Technical Service Bulletin  
21-15-02 - Frozen Charge Air Cooler - Engine Will Not Start

Transaction No.: 2025464/7  
Release date: Jan 20, 2015

21 15 02 January 20, 2014 2025464 Supersedes T. B. V211404 dated May 1, 2014 for labor operation update.

**Frozen Charge Air Cooler – Engine Will Not Start**

**Figure 1**

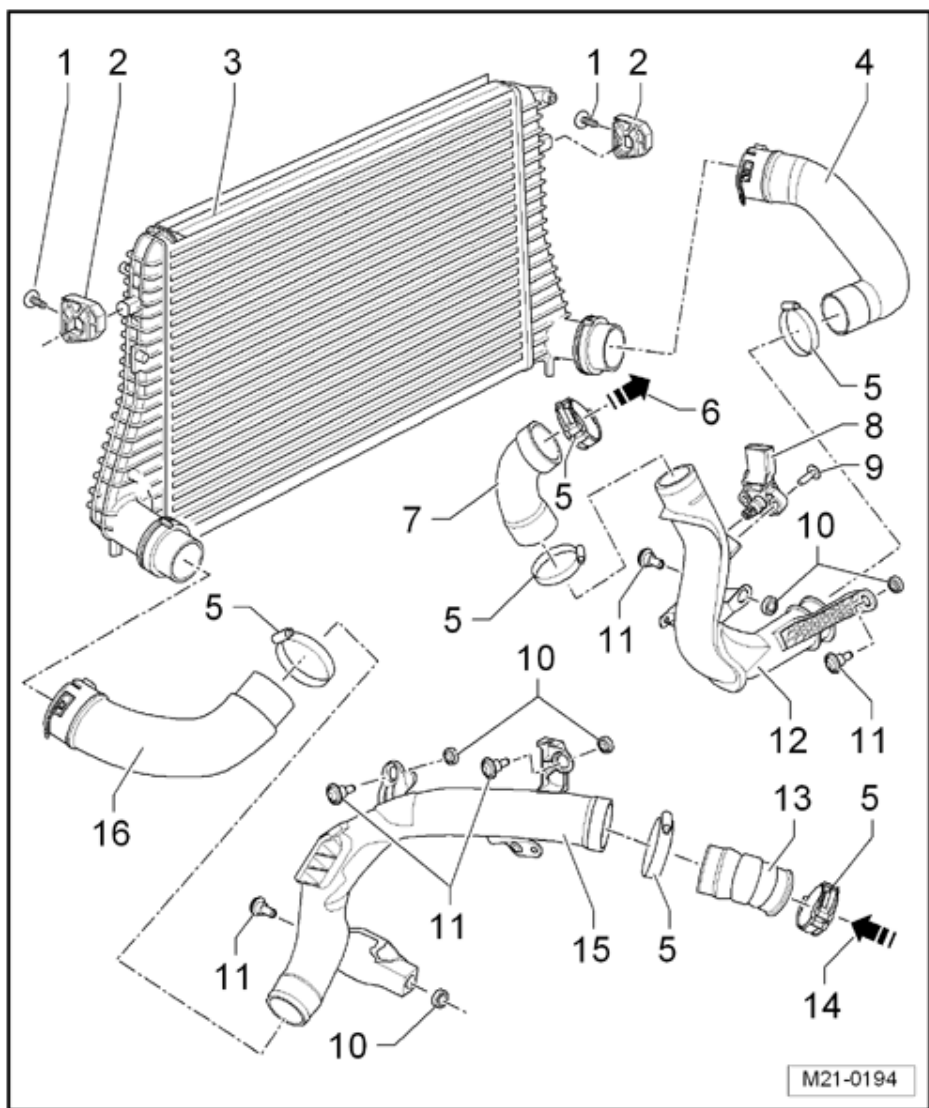
Engine will not start after standing in cold weather below 0°C (32°F), MIL may be illuminated with various induction and/or boost system faults stored in ECM.

Moisture from the intake air condenses and collects in the charge air cooler. At cold temperatures this moisture can freeze causing blockage of the intake air system.

Install revised charge air cooler kit P/N 1K0 198 803B to avoid the formation of this moisture in the boost system.

- Lock carrier in service position. See Repair Manual Group 50 in Elsa.
- Separate A/C condenser from charge air cooler.
- Remove radiator and radiator fan assembly.
- Remove the original charge air cooler (item 3 in figure 1) from the vehicle.

- Remove the lower charge pressure hoses ( items 4 and 16 in figure 1) and clean of any moisture, ice crystal formation or sludge. See Repair Manual Group 21, Turbocharger/G-Charger, Description and Operation, Component Overview, in Elsa.

- Remove cold side charge air pipe (item 12 in figure 1) and pressure hose to throttle valve (item 7 in figure 1).
- Separate the A/C condenser from the charge air cooler.
- Remove the radiator and radiator fan assembly.
- Separate the charge air pressure sensor -G31- from cold side charge air pipe.
- Install charge air pressure sensor -G31- from kit to cold side charge air pipe.
- Loosely fit the pressure hose with new temperature switch to the cold side charge air pipe.

- Install the cold side charge air pipe (item 12 in figure 1) and connect the charge air pressure sensor -G31- electrical connector.

- Cut vacuum source hose where indicated in figure 7, and install splice.
- Install the revised charge air cooler (item 3 in figure 1) with regulating flap and connect the regulating flap vacuum hose.
- Re-assemble all charge air pipe connections.
- Connect A/C condenser to charge air cooler using fasteners from kit, and install radiator with fan assembly.
- Reassemble front carrier.
- Re-aim headlights.
